**ANNEX 12**

**RESOLUTION MSC.226(82)**

**ADOPTION OF AMENDMENTS TO THE REVISED RECOMMENDATION  
ON TESTING OF LIFE-SAVING APPLIANCES, AS AMENDED**

**Figure 4 – Stretcher dimensions (mm)**

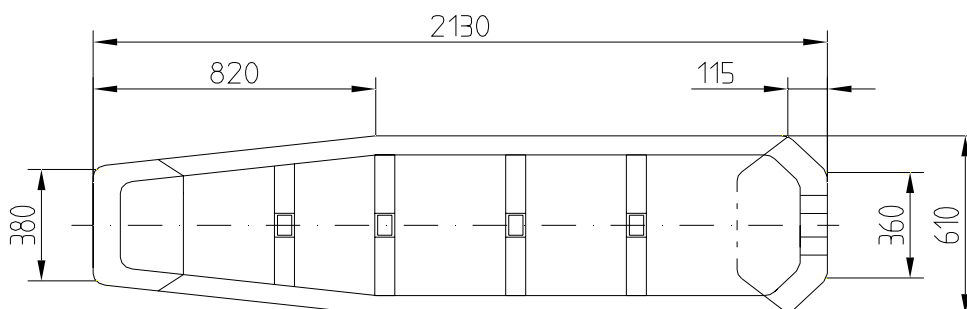
25 In paragraph 7.1.3, in the second sentence, the words “on a stretcher of similar dimensions to those shown in figure 4” are inserted between the words “lie down” and “and the others” and the following figure is inserted after the paragraph:
